# HISTORIC AND DESIGN REVIEW COMMISSION

June 21, 2024

**HDRC CASE NO:** 2024-188  
**ADDRESS:** 509 NOLAN ST  
**LEGAL DESCRIPTION:** NCB 546 BLK 19 LOT W 51.08 FT OF 12  
**ZONING:** R-6, H  
**CITY COUNCIL DIST.:** 2  
**DISTRICT:** Dignowity Hill Historic District  
**APPLICANT:** john moreno/jeveconst  
**OWNER:** Mary Martin/JEVE CONSTRUCTION LLC  
**TYPE OF WORK:** Front porch column replacement, fenestration modifications  
**APPLICATION RECEIVED:** May 13, 2024  
**60-DAY REVIEW:** July 12, 2024  
**CASE MANAGER:** Edward Hall

**EXAMPLE OF PROPOSED COLUMNS - PROVIDED BY APPLICANT**

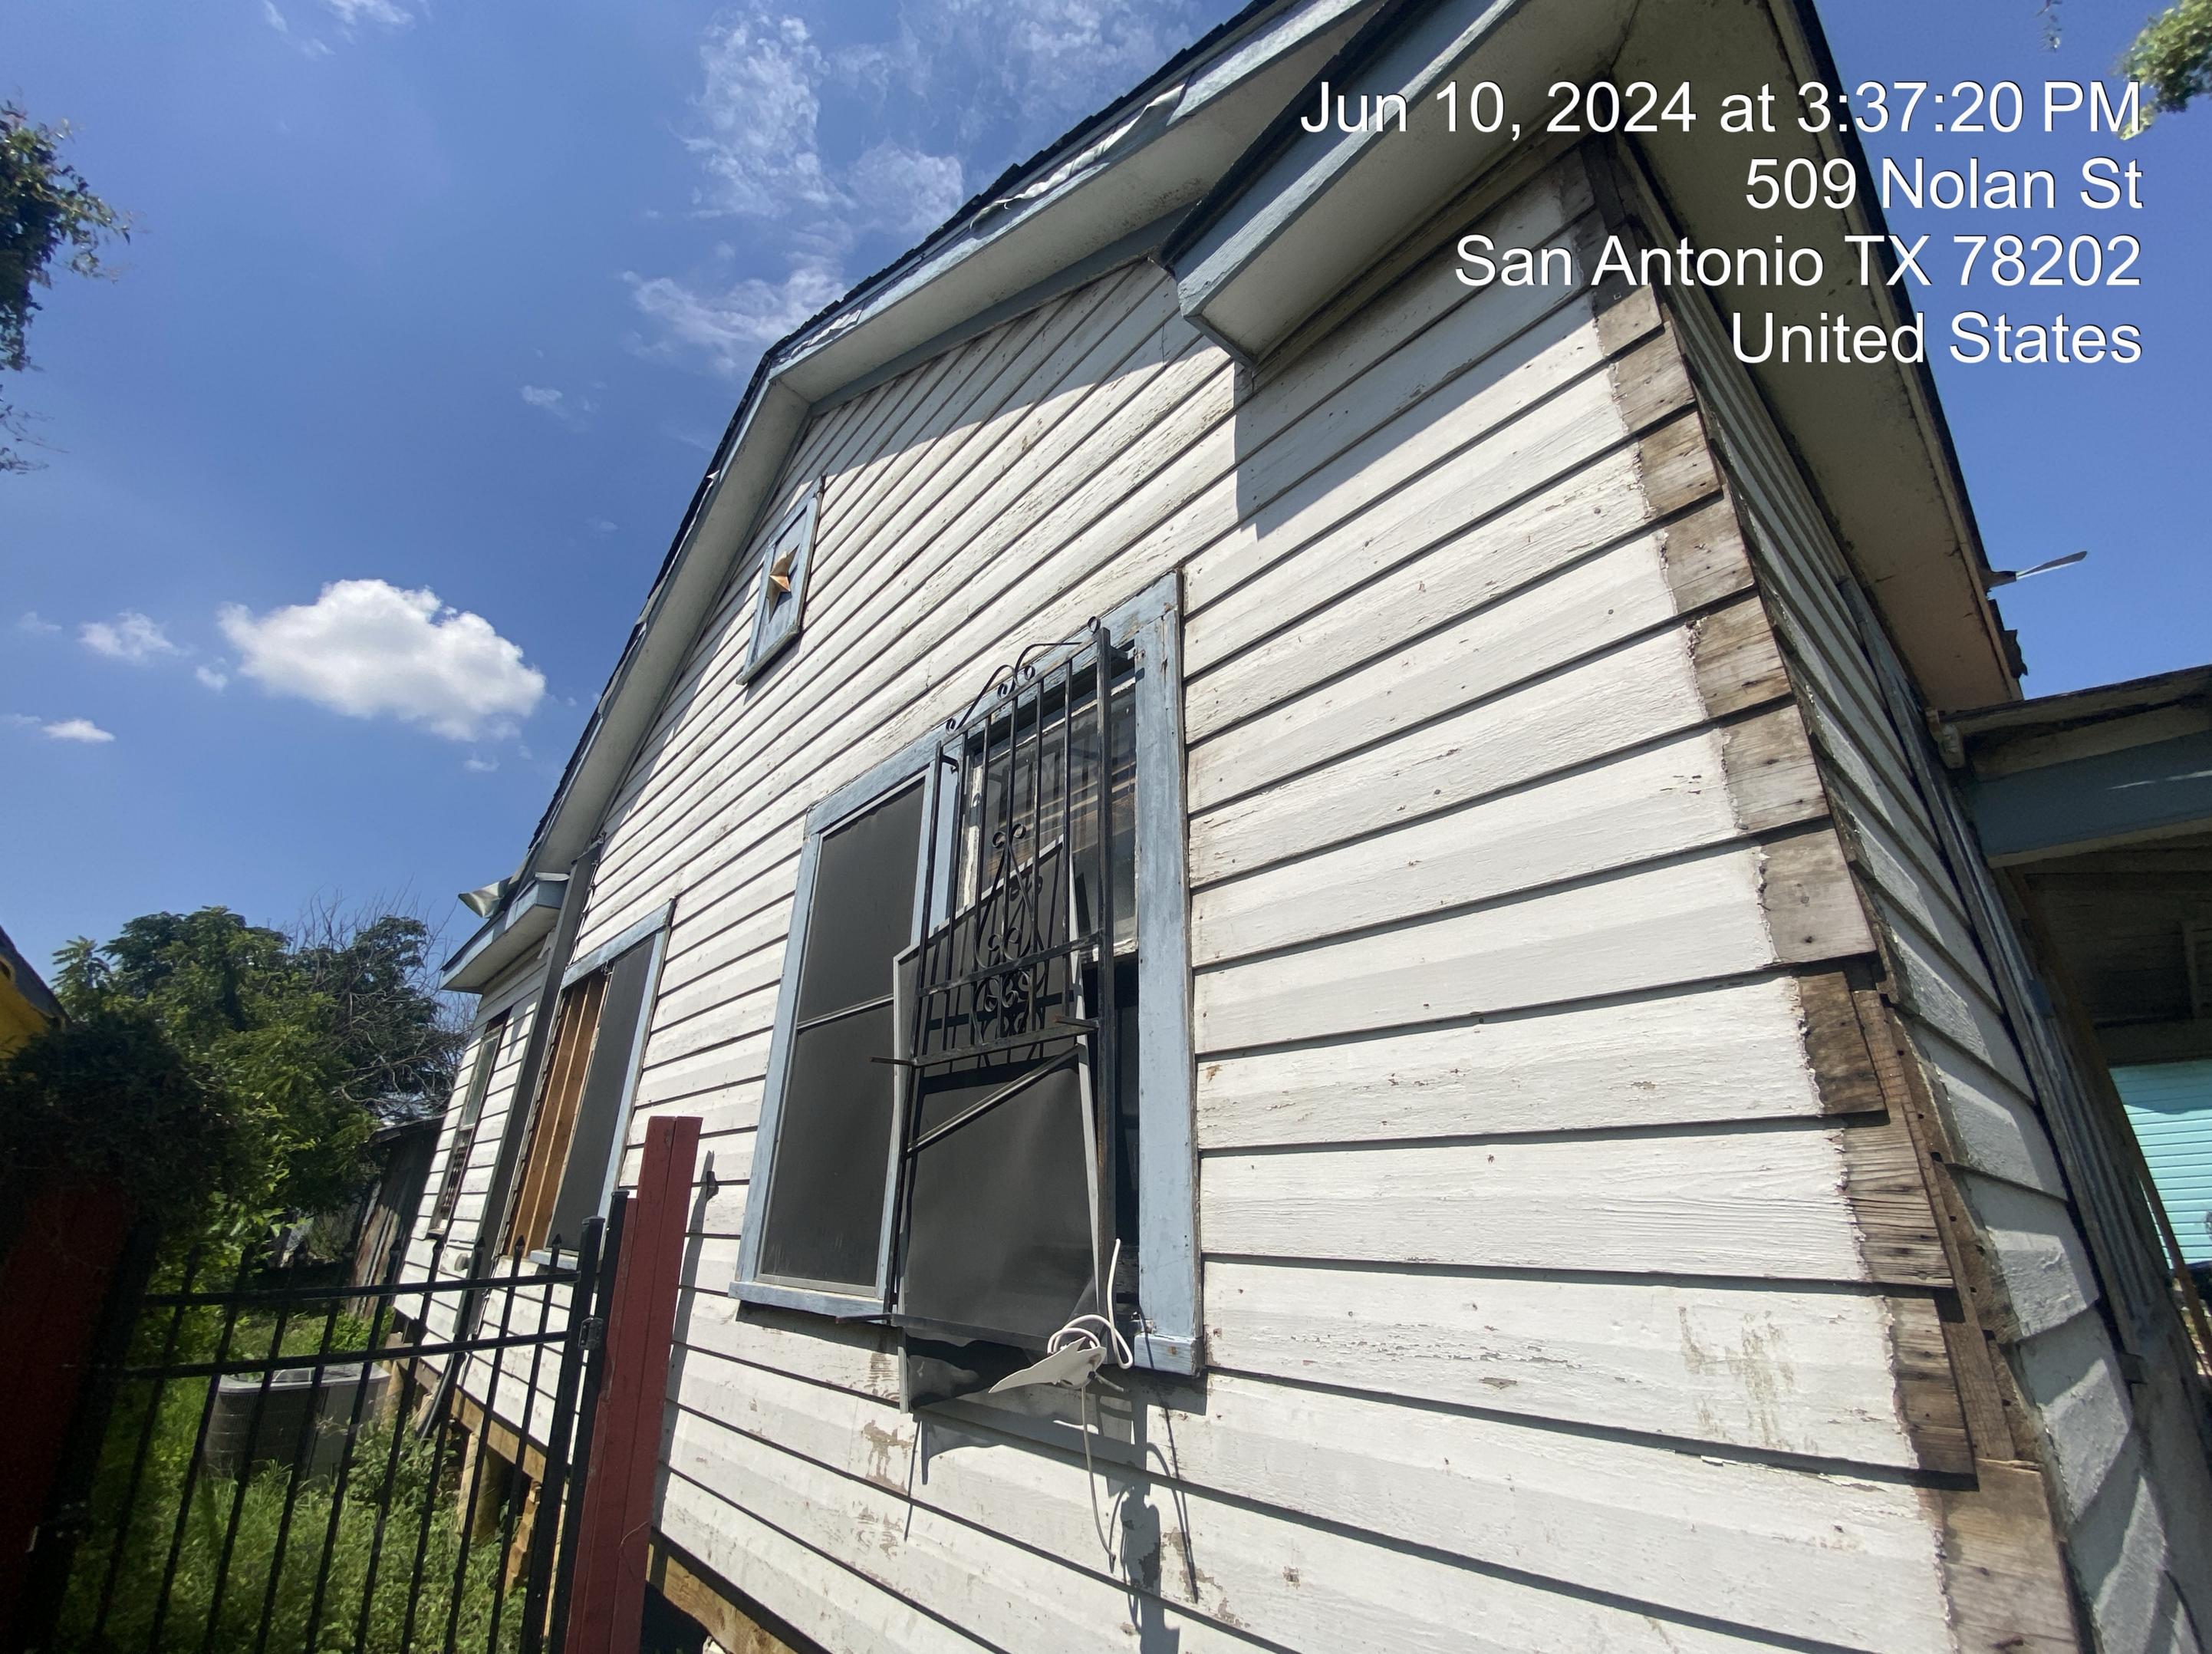
- e. FRONT PORCH COLUMNS – The applicant has proposed to replace the existing porch columns with Craftsman Style porch columns. As noted in finding a, many elements currently present on this structure are not original, including the front porch and its columns. The Guidelines for Exterior Maintenance and Alterations 7.B.iii. notes that replacement elements should be simple as to not distract from the historic character of the building. Additionally, the Guidelines note that new elements that create a false sense of historic appearance should not be added. Staff finds that the installation of Craftsman Style columns on a structure that is not Craftsman is not consistent with the Guidelines. Staff finds that the column specifications outlined in the adopted Policy Guide for Porch Repair and Reconstruction should be followed; columns should feature capital and base trim and should reference the existing columns regarding profile and appearance. While the current columns are not original (the entire porch is not original), staff finds them to be generally architecturally appropriate for the structure.

1. Staff does not recommend approval of item #1, column replacement, as proposed, based on finding e. Staff recommend the applicant follow the column specifications outlined in the adopted Policy Guide for Porches and Reconstruction should be followed; columns should feature capital and base trim and should reference the existing columns regarding profile and appearance. While the current columns are not original (the entire porch is not original), staff finds them to be generally architecturally appropriate for the structure. Staff recommends the applicant install columns to match the existing.
